BREWSTER ST:

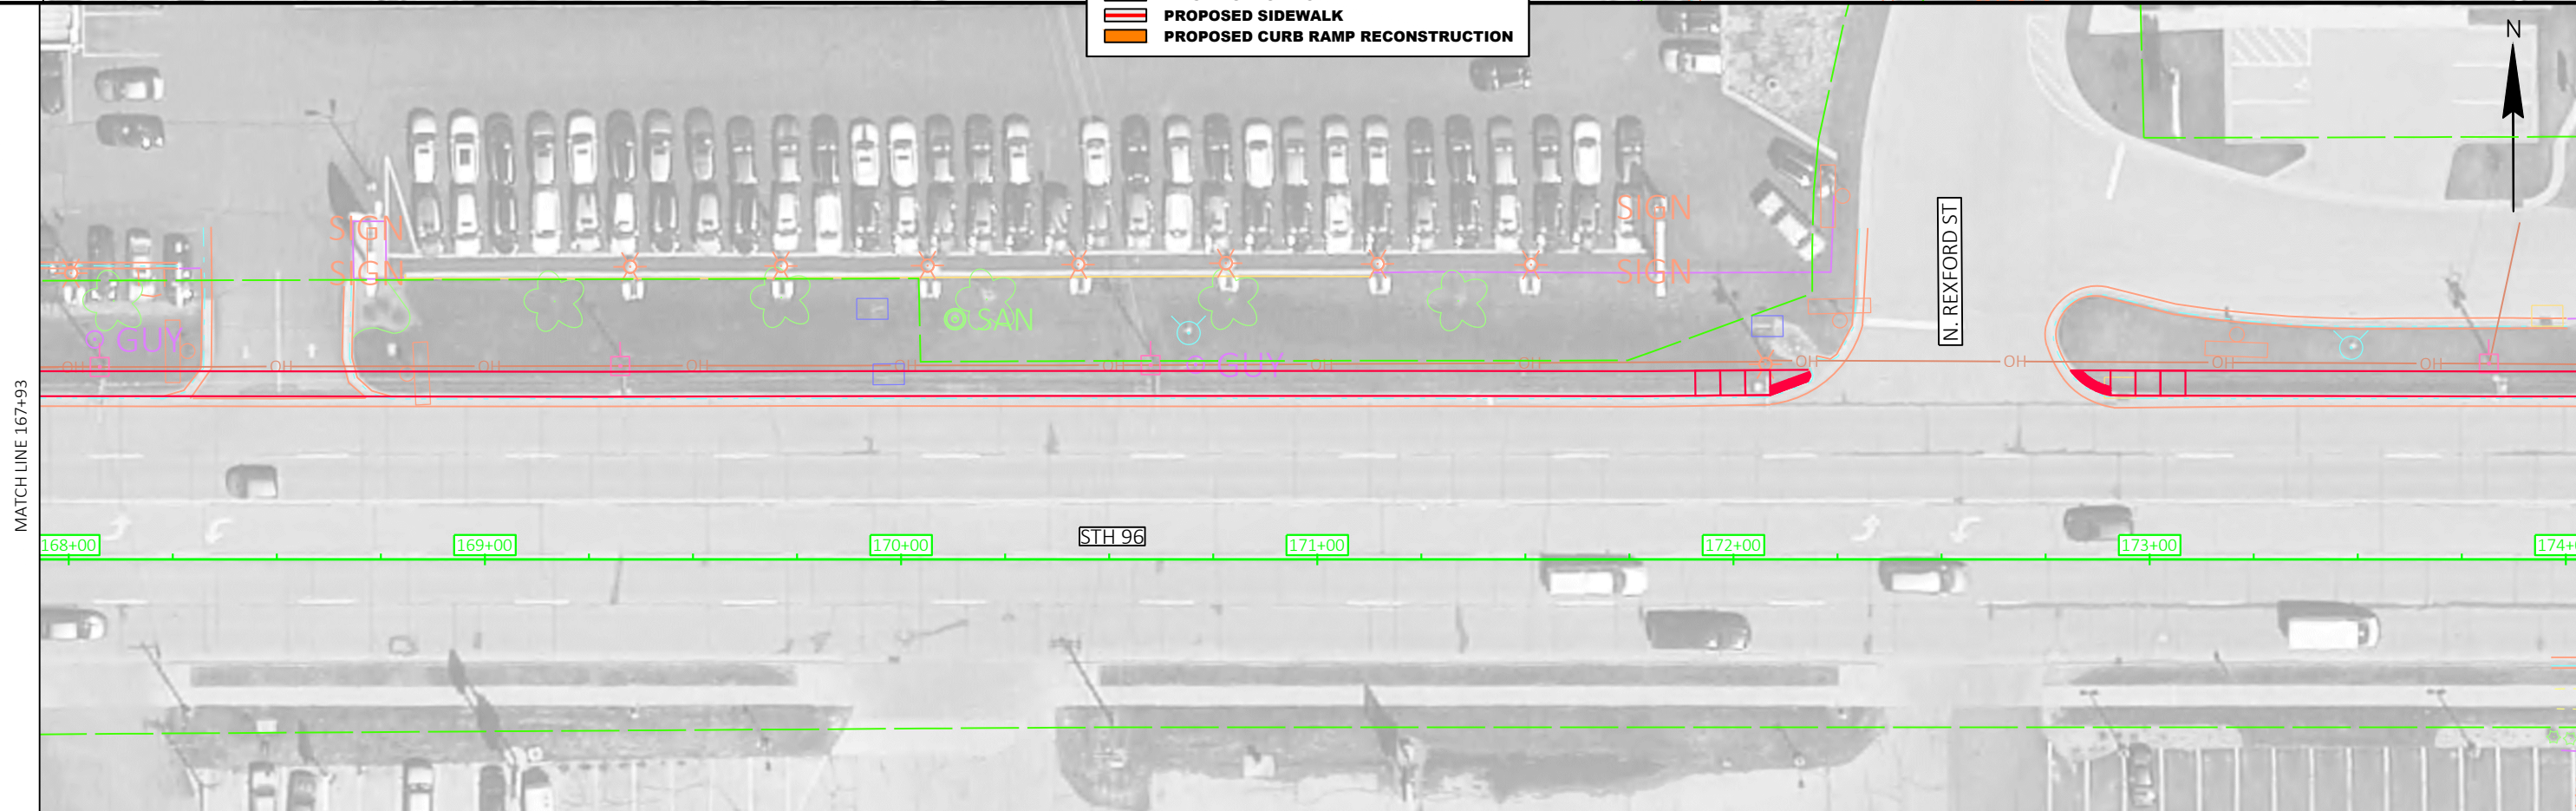
- DEEP DITCH
- WETLAND IMPACTS IN DITCH
- NARROWING THE TERRACE DOES NOT AVOID ANY UTILITY CONFLICTS. IT DOES EASE ISSUES WITH DITCH SLOPE.
- MOVED CROSSING NORTH TO AVOID RIGHT TURN VEHICULAR MOVEMENT AND TO MATCH IN WITH TOWN'S PROPOSED SIDEWALK ON LEFT SIDE OF BREWSTER STREET
- TOWN'S PROPOSED CURB RAMP DOES NOT PROJECT PEDS ACROSS BREWSTER STREET AND IS ON TOP OF EXISTING/PROPOSED SANITARY
- WILL NEED TO EXTEND CURB & GUTTER IN NE QUAD OF BREWSTER STREET
- 3' TERRACE USED HERE

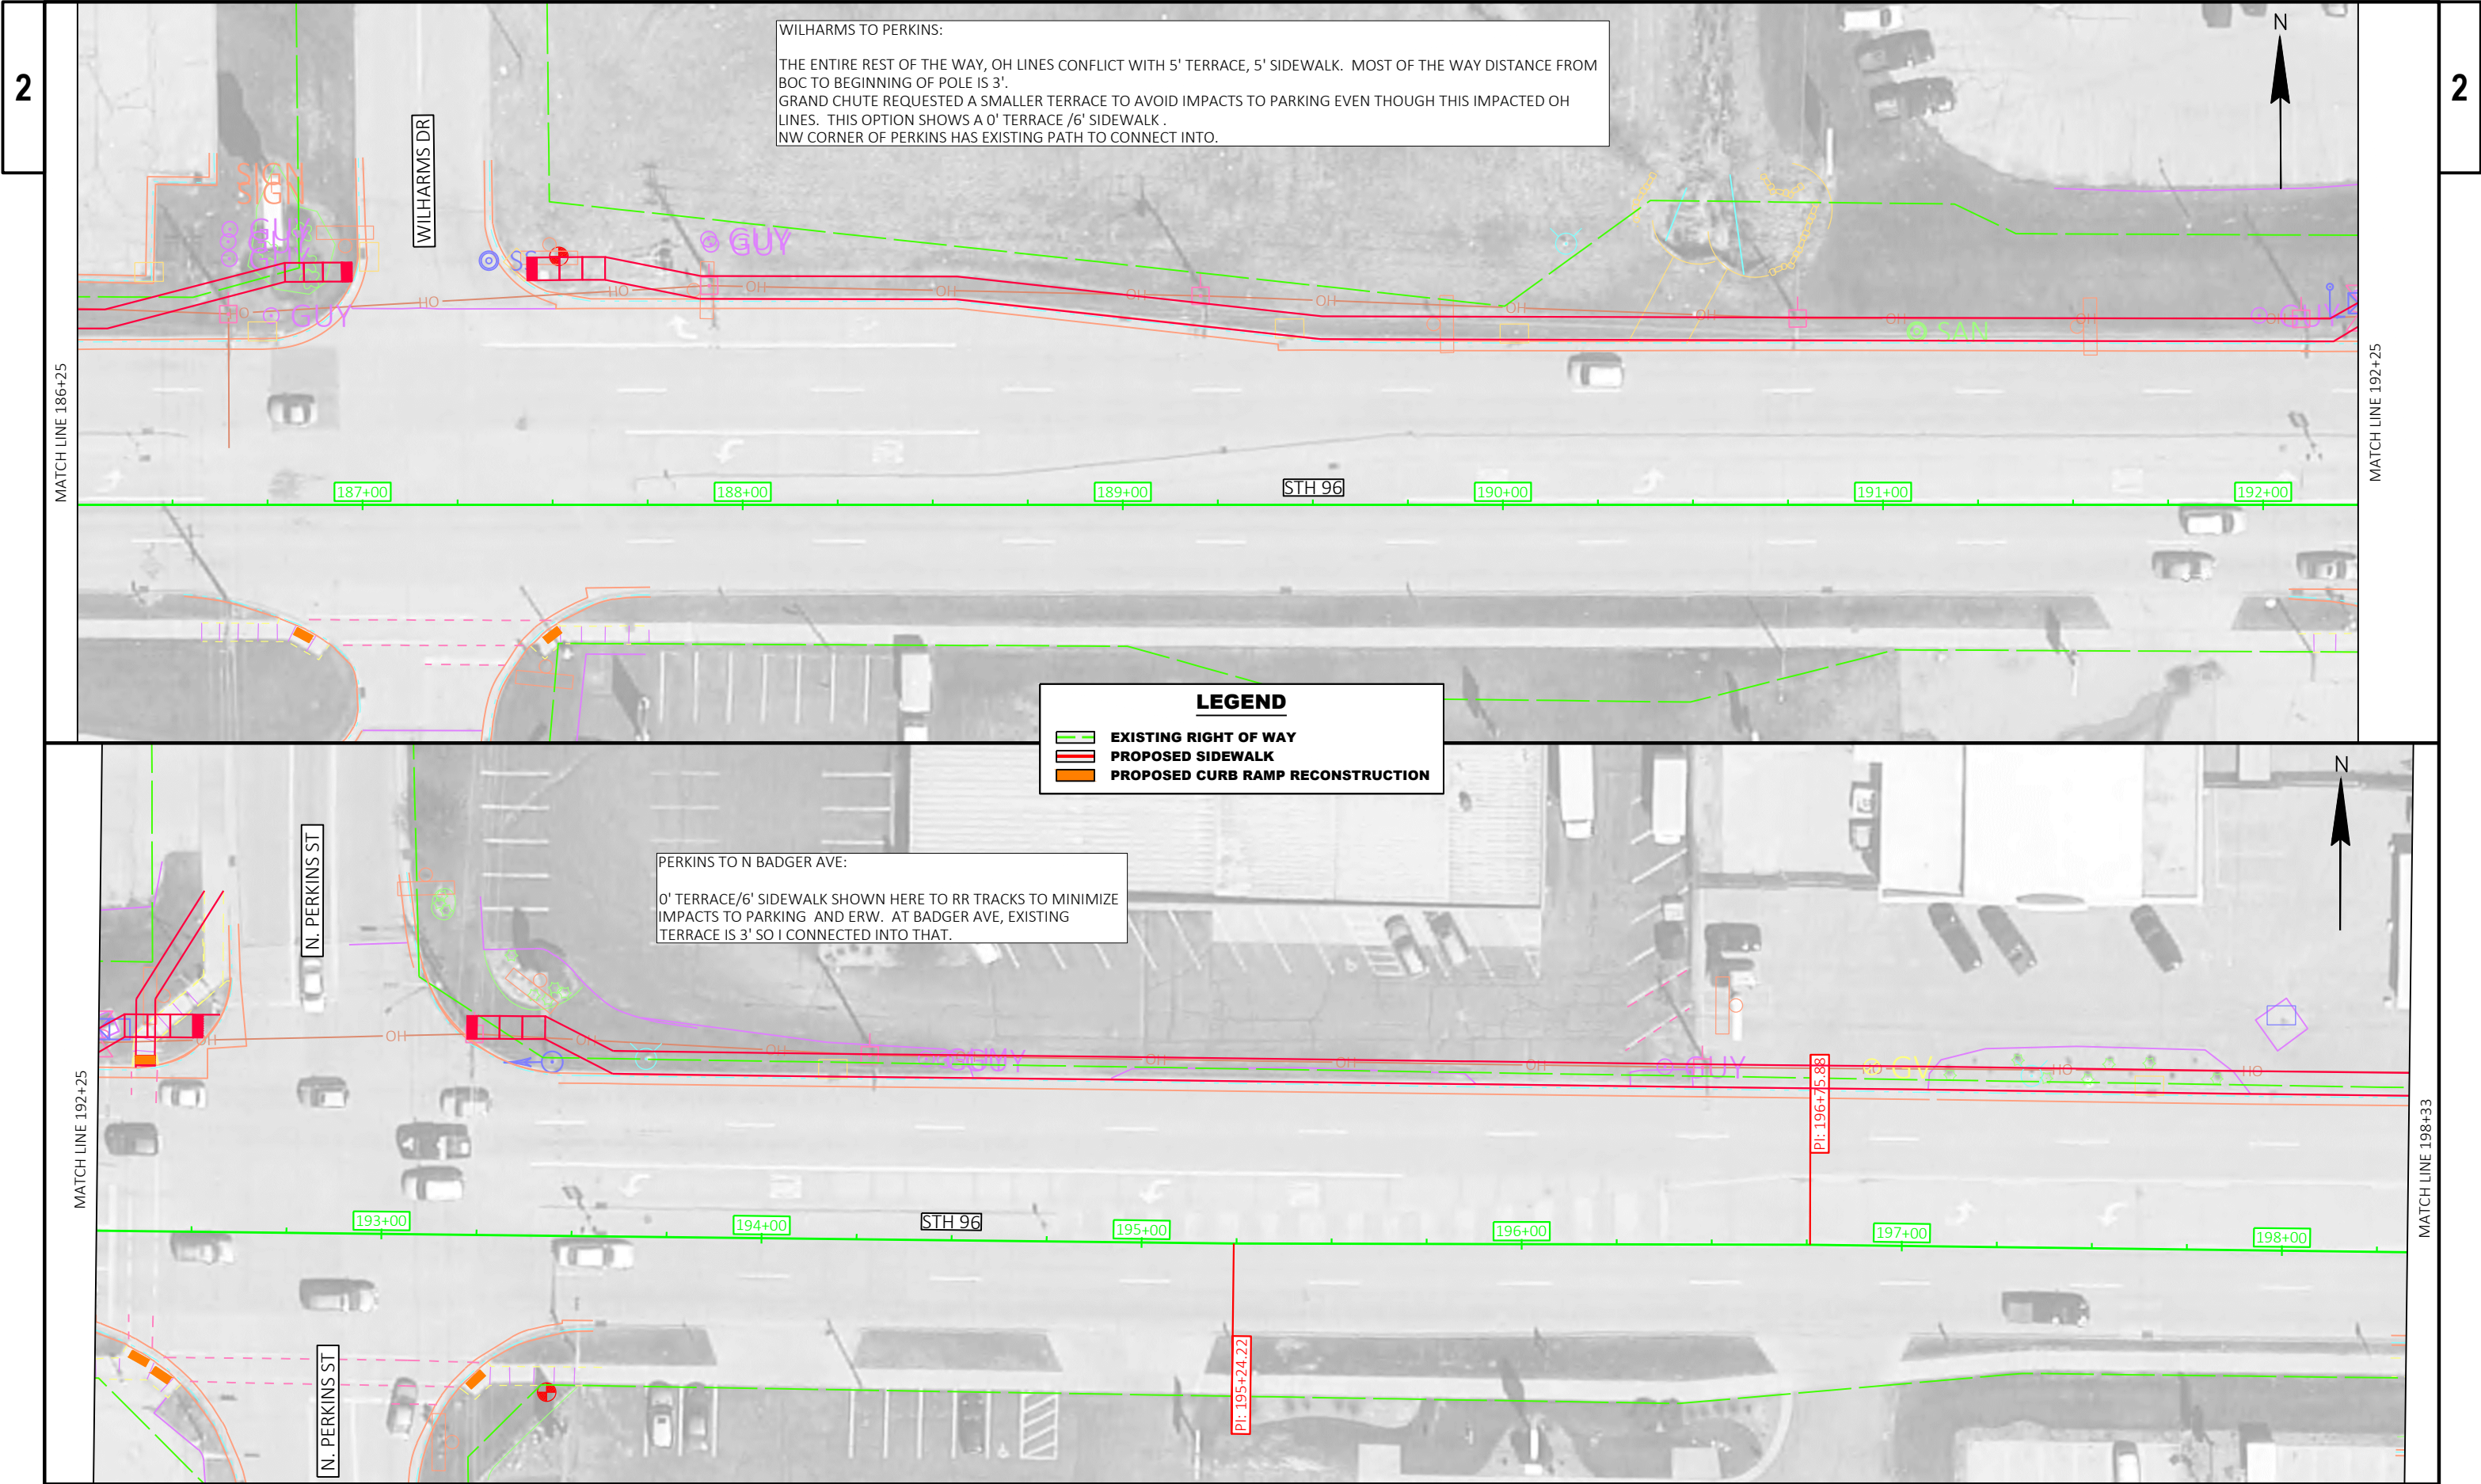
WILHARMS TO PERKINS:
THE ENTIRE REST OF THE WAY, OH LINES CONFLICT WITH 5' TERRACE, 5' SIDEWALK. MOST OF THE WAY DISTANCE FROM BOC TO BEGINNING OF POLE IS 3'.
GRAND CHUTE REQUESTED A SMALLER TERRACE TO AVOID IMPACTS TO PARKING EVEN THOUGH THIS IMPACTED OH LINES. THIS OPTION SHOWS A 0' TERRACE /6' SIDEWALK .
NW CORNER OF PERKINS HAS EXISTING PATH TO CONNECT INTO.
